MSF CONSTRUCTION JV - REVISED BARRIER CONCEPT

Response to Amendment 0001 | West-side fire-lane coordination | 12 August 2027

REVISED COMMAND POST BARRIER CONCEPT | RESPONSE TO AMENDMENT 0001

G-07 MSF CONSTRUCTION JV

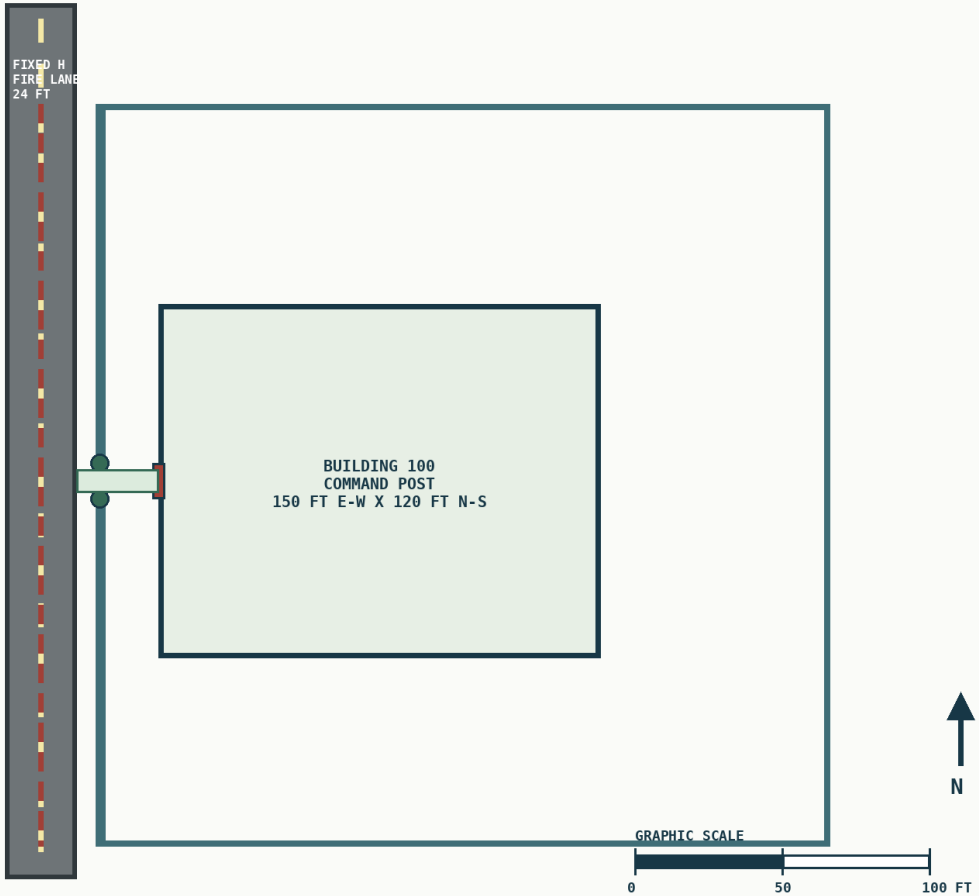
ORIGINAL
G-04: 40 FT WEST

REVISED
20 FT WEST

ROAD
28-52 FT WEST OF BUILDING

SEPARATION
8 FT TO EAST ROAD EDGE

OTHER SIDES
N 68 / E 78 / S 64 FT - UNCHANGED

ACCESS
12-FT CONTROLLED OPENING ALIGNED WITH WEST FIRE INGRESS

This sheet revises only the west barrier alignment. All other portions of the offeror's original proposal remain unchanged.
